As-Built Baseline Monitoring Report
FINAL VERSION
Horne Creek Tributaries Mitigation Project
Monitoring Year 0
Calendar Year of Data Collection: 2020

NCDEQ DMS Project Identification # 100026
NCDEQ DMS Contract # 7181
Yadkin River Basin (Cataloging Unit 03040101)
USACE Action ID Number: SAW-2017-01510
NCDEQ DWR Project # 2017-1156
Surry County, NC
Contracted Under RFP # 16-006993
Data Collection Period: May 2020
Submission Date: August 2020

RE: WLS Responses to NCDEQ DMS Review Comments for Task 6 Submittal, Draft Baseline Monitoring Report for the Horne Creek Tributaries Mitigation Project, DMS Full-Delivery Project ID #100026, Contract #7181, Yadkin River Basin, Cataloging Unit 03040101, Surry County, NC

**Horne Creek Tributaries Mitigation Project
Longitudinal Profile - R5
As-Built (MYO 2020)**

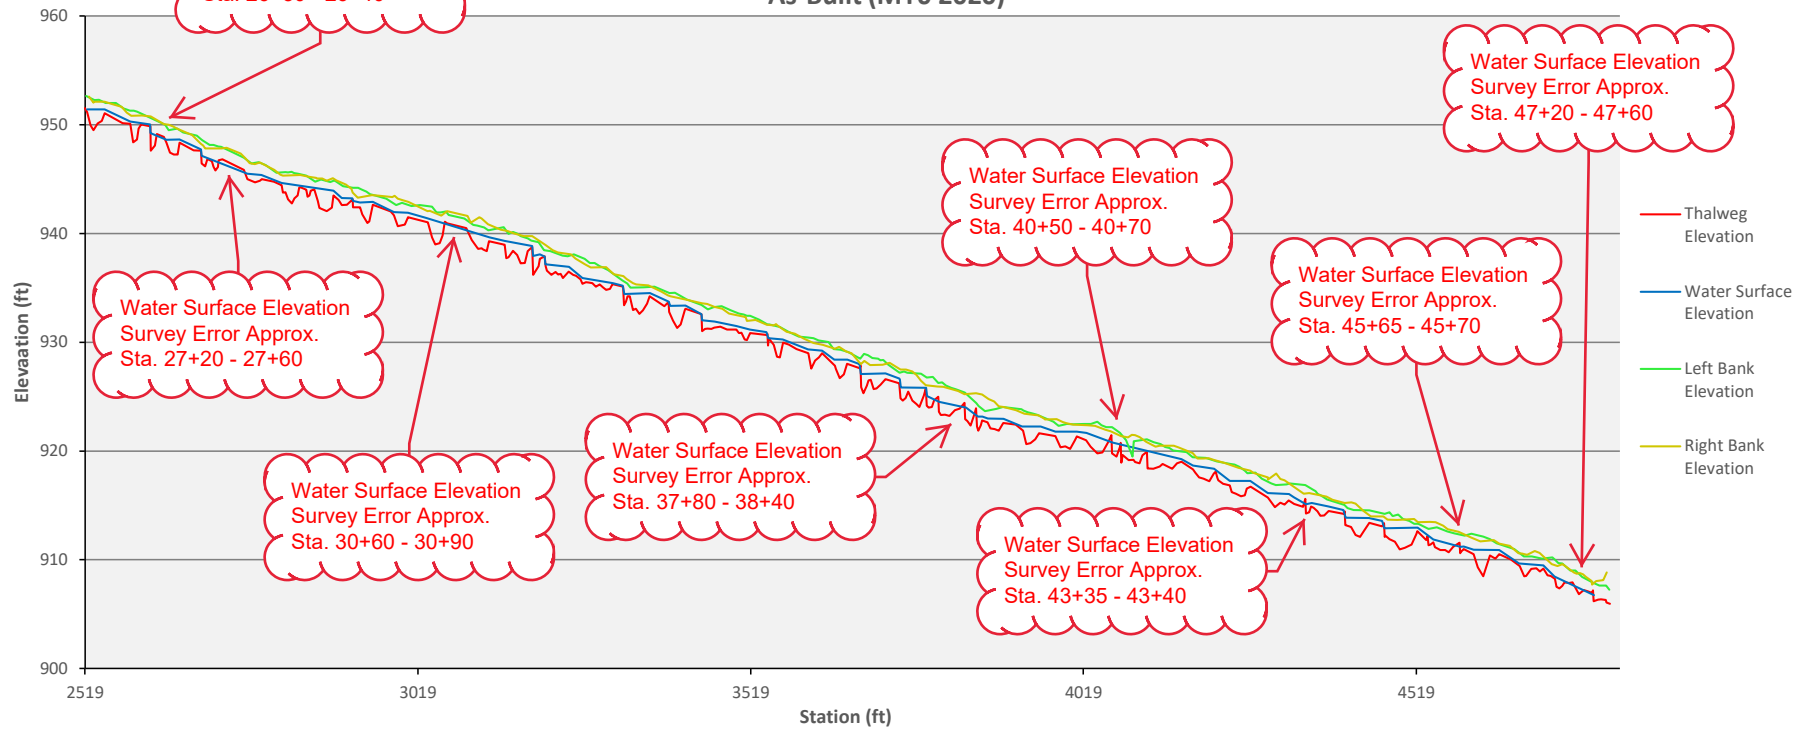
- **The R5 profile shows numerous occasions where the water surface cuts through the thalweg elevation. Are these survey error, piping, dry channel, or other?** WLS Response: There are eight locations on R5 where the water surface profile cuts underneath the thalweg due to missed survey points (no water surface shots at the structure inverts). There are no locations on R5 where piping is occurring, nor is the channel dry. WLS has included call outs for the locations along R5 that have the water surface elevation clipped through the thalweg due to survey error.

SHEET NUMBER
5

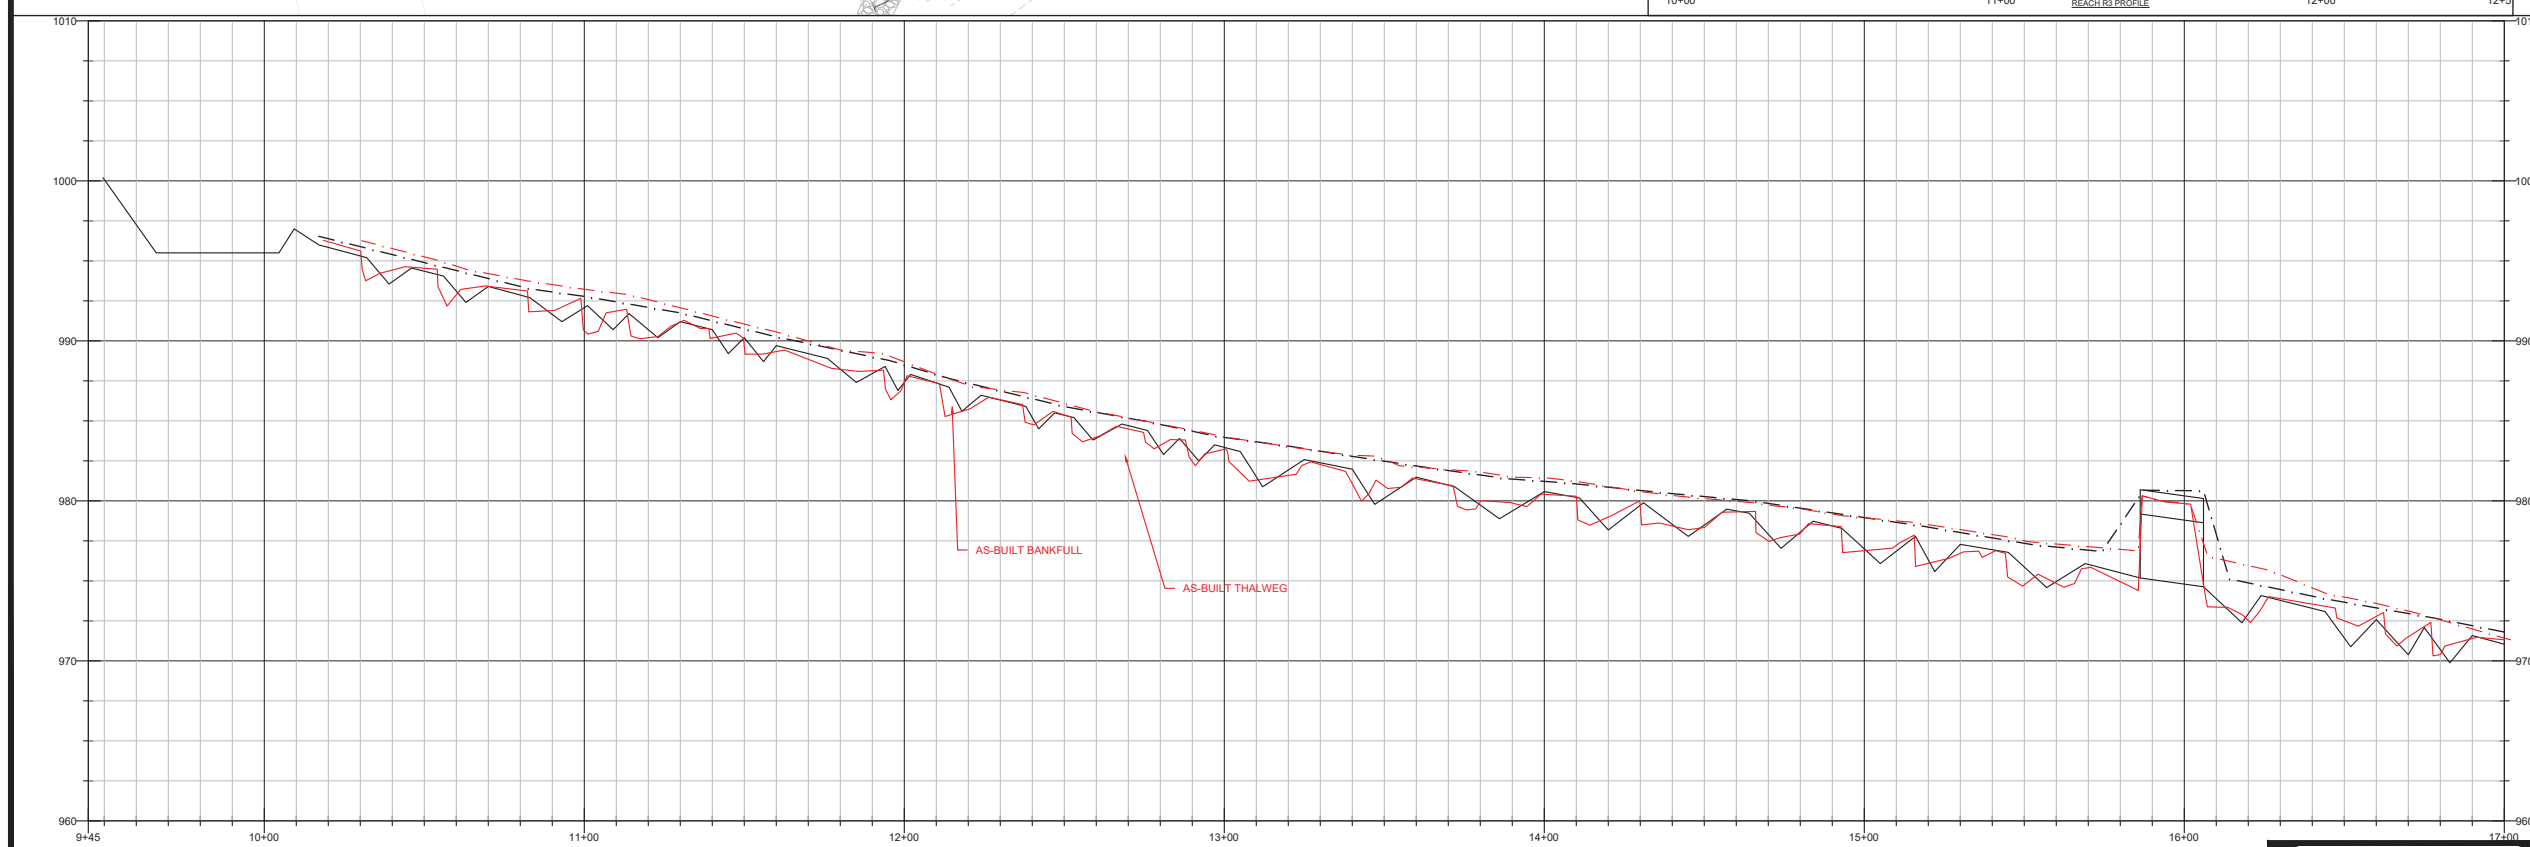
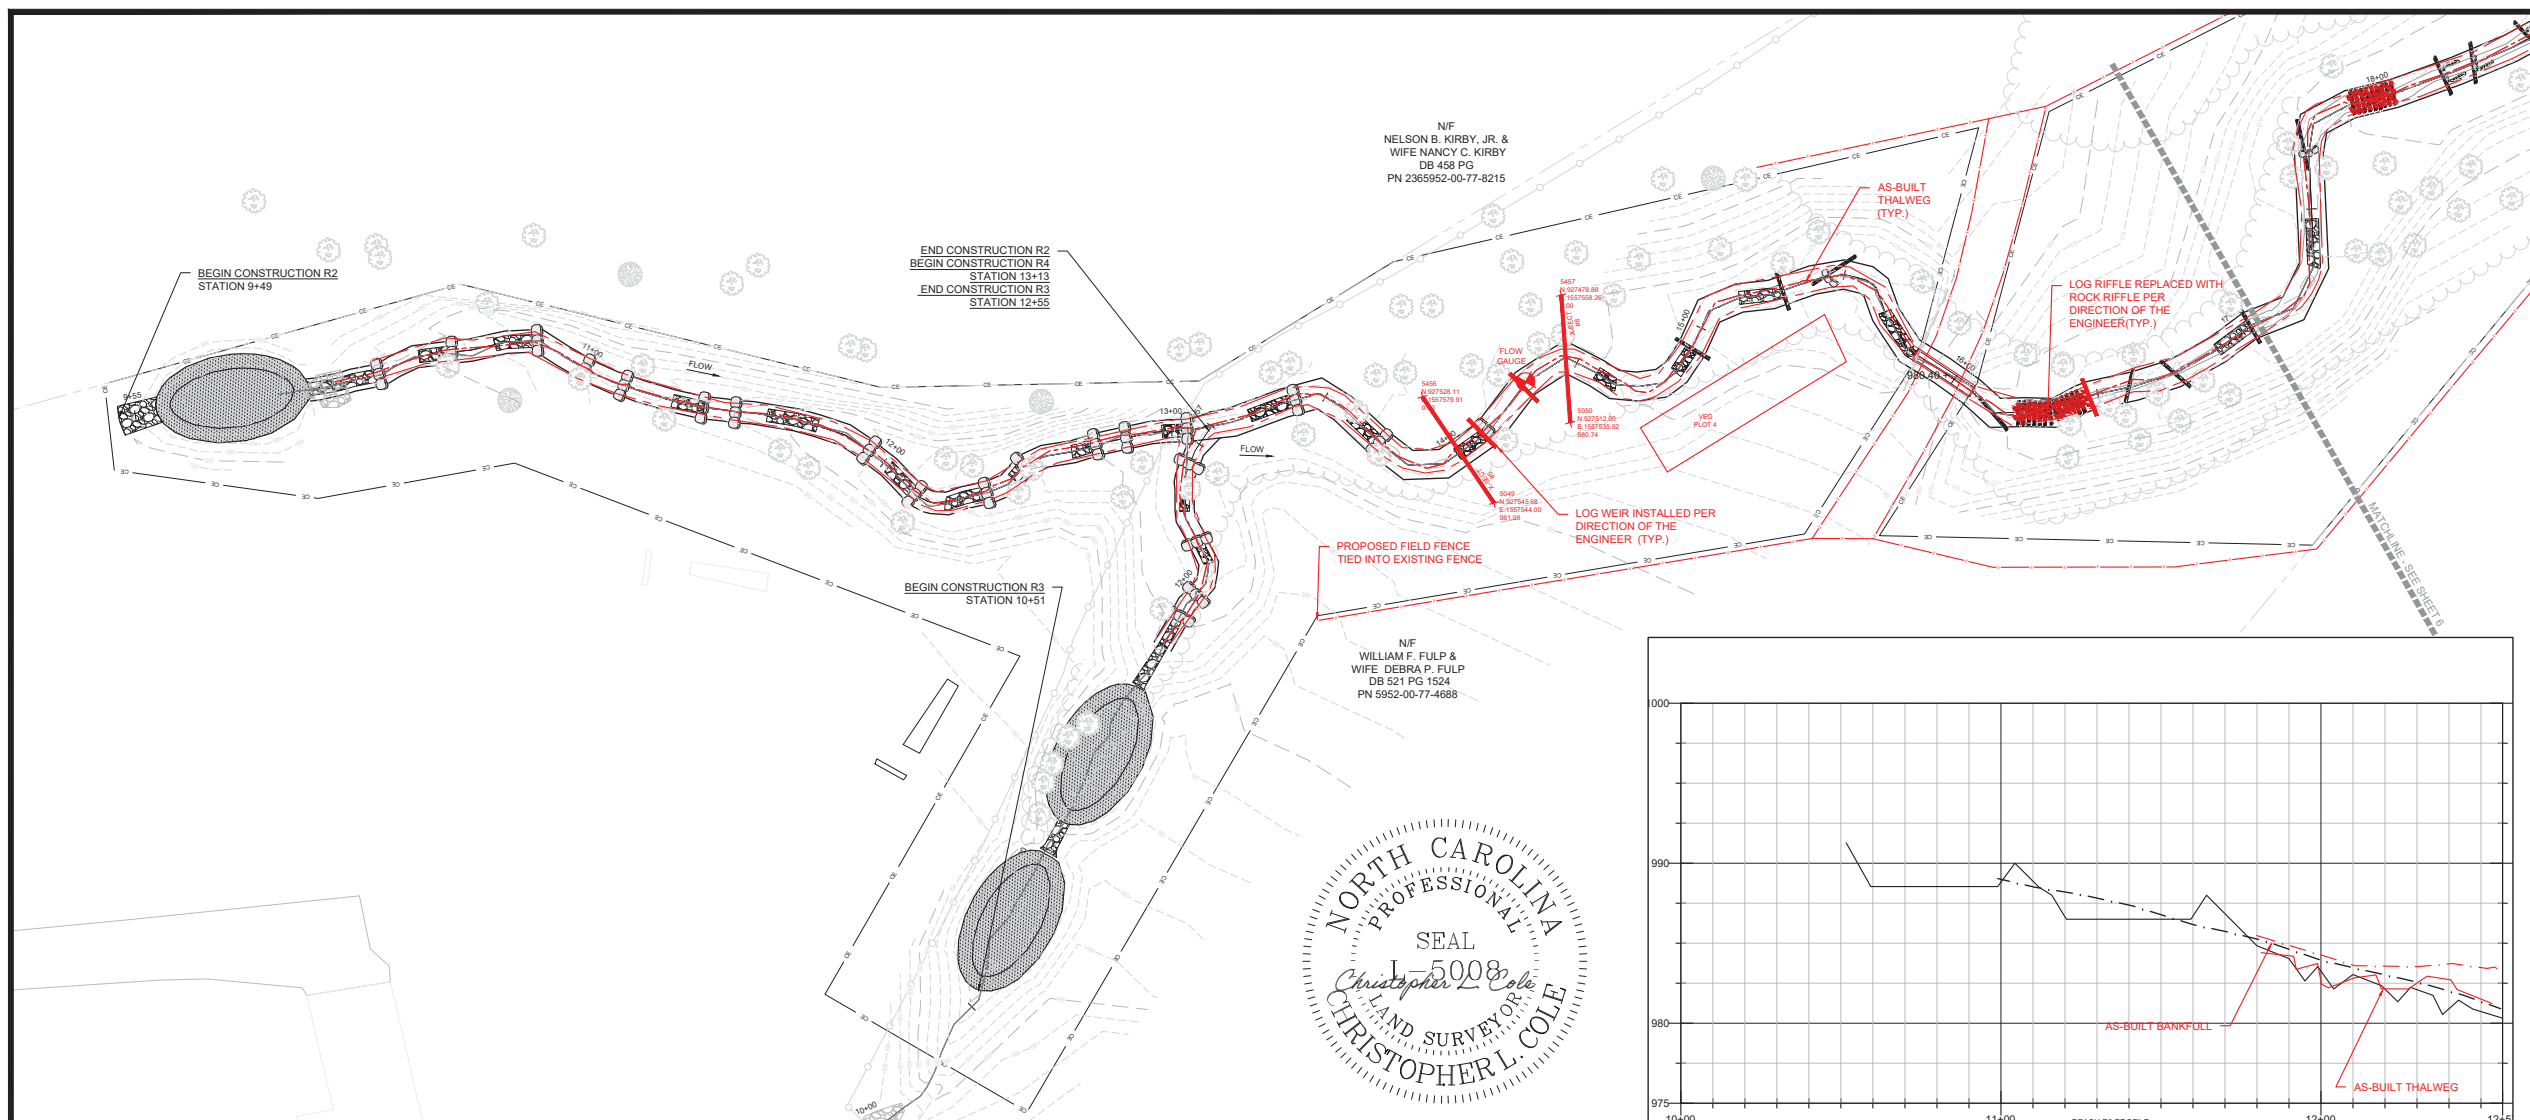
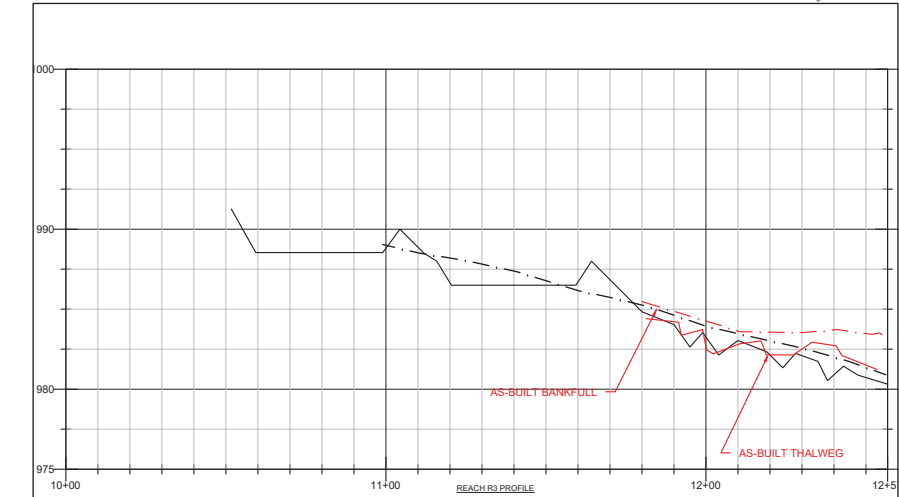
• **As-built Sheet 5: R4 Asbuilt Bankfull line does not appear correctly in profile downstream of culvert crossing. Revise as necessary.** WLS Response: The as-built bankfull line has been revised on Sheet 5.
